Subject: Duke Energy Corporation
Catawba Nuclear Station, Unit 2
Docket No. 50-414
Second Ten Year Inservice Inspection Interval
Steam Generator C Hot Leg Nozzle Welds

RESPONSE TO NRC REQUEST FOR ADDITIONAL INFORMATION

CATAWBA NUCLEAR STATION, UNIT 2

CNS Steam Generator 2C Hot Leg Nozzle Indication

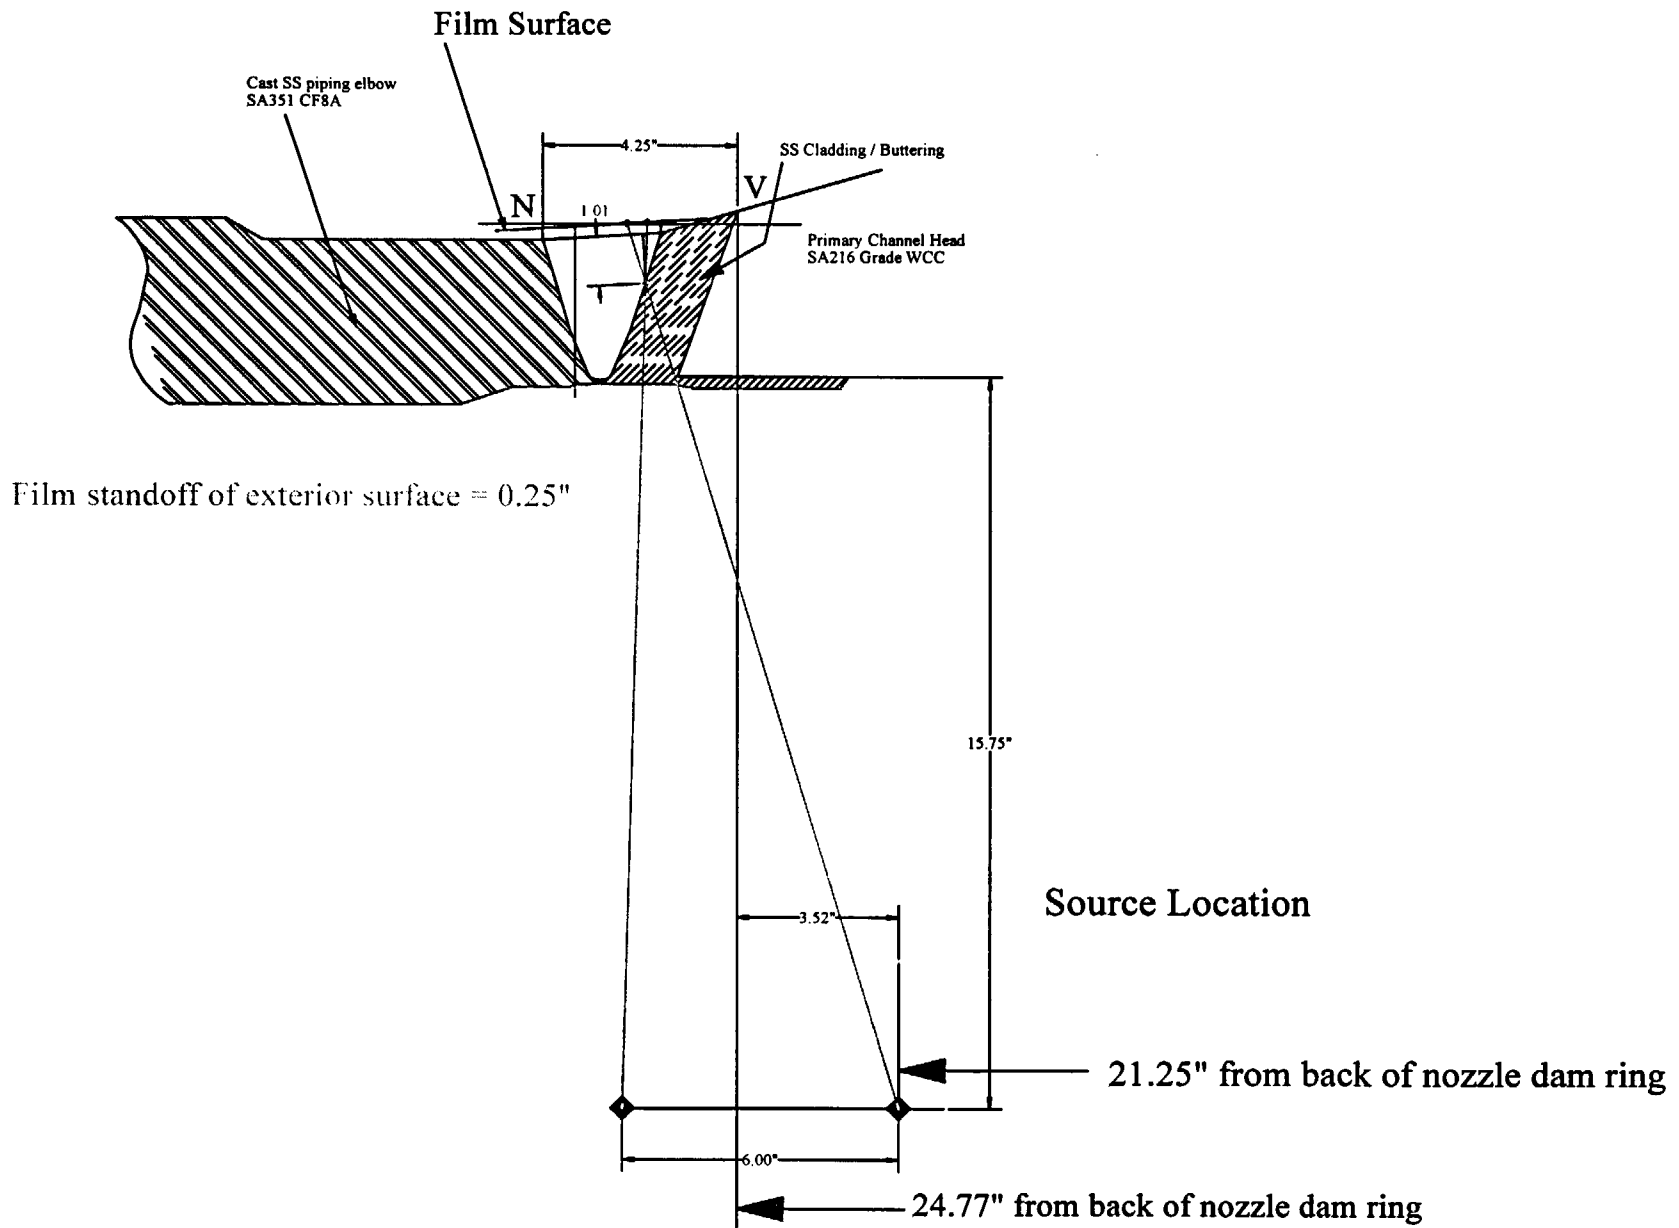
1. In the letter dated October 19, 2004, you stated, "[t]he indication was located near the interface between the safe-end and field weld at the bottom of the nozzle." Please confirm whether the flaw indication is in the safe end or in the field weld.

The flaw is located at the boundary between the safe end (actually a stainless steel buttering of the carbon steel nozzle) and the stainless steel field weld. A sketch is attached showing the location of the flaw relative to the safe end buttering and the field weld.

Figure A-3.7 Evaluation Chart for Steam Generator Inlet Nozzle Safe-End to Pipe Weld
(Stainless Steel)

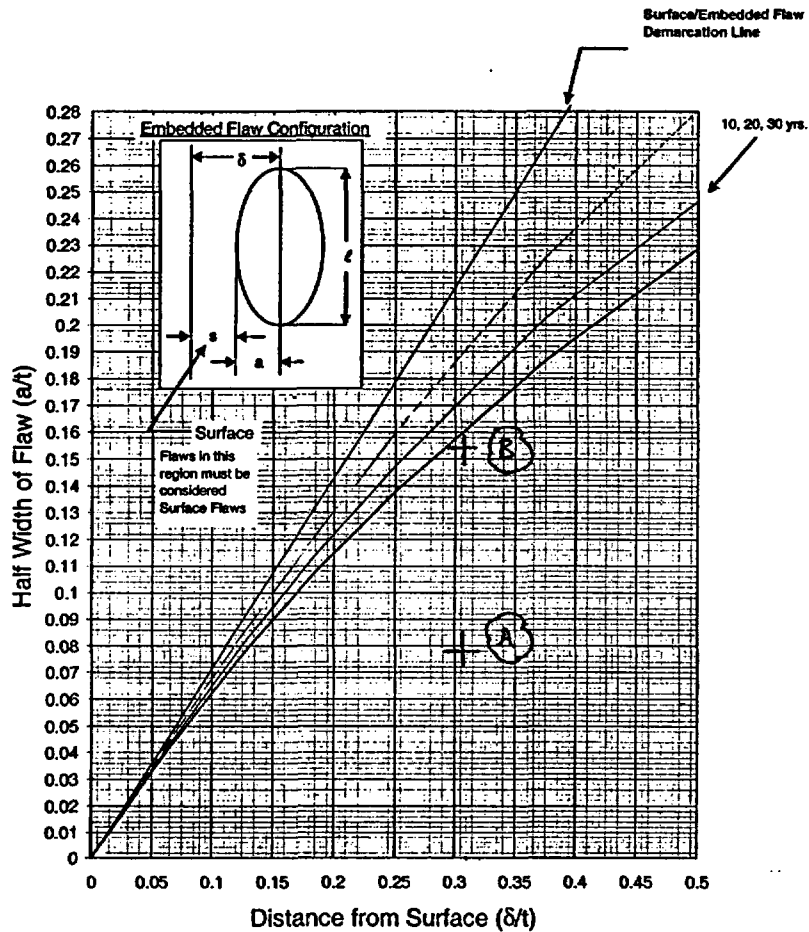
2. In the letter dated October 19, 2004, you stated, "[t]his letter submits the fracture mechanics analysis to the NRC (see attachment)". The NRC staff did not find in your submittal an evaluation of the detected flaw indication (1 inch long circumferential embedded flaw, 1.01 inches from the outside diameter of the pipe) using WCAP-15658-P, Revision 1. Please provide this information. The response should include the WCAP figure number (Figure A-4.6, Figure A-4.7, Figure A-4.8, or Figure A-4.9) that you used for evaluation of the detected flaw in the steam generator primary nozzle weld region. The response should also include the depth of the detected flaw (the size of the flaw in the wall thickness direction).

δ = distance to flaw centerline
 δ = 1.01 in
 δ / t = 1.01 / 3.25
 δ / t = 0.311
 a / t = 0.25 / 3.25
 a / t = 0.077

The δ / t and a / t parameters may be plotted on Figure A-3.7 to determine the acceptability of the flaw. This point (A) is shown on the attached sketch.

Again, the δ / t and a / t parameters have been plotted on Figure A-3.7 as point (B) to determine the acceptability of the flaw.

In both cases evaluated above, it is clearly evident that the flaw is within the bounds of the acceptability provided by Figure A-3.7 of WCAP-15658-P, Revision 1. As a result, the piping containing this flaw is acceptable for continued service for the design life of the plant. The figure in WCAP-15658-P, Revision 1 indicates 10, 20, and 30 year acceptance lines. These lines are related to the design number of occurrences of transients used in the fatigue crack growth calculation. As such, this indication is acceptable for the life of the plant provided a prorated value ($30 / 40 = 75\%$) of the design number of occurrences are not exceeded between now and the end of plant life. This limit on fatigue cycle counts will be tracked under our fatigue management program.
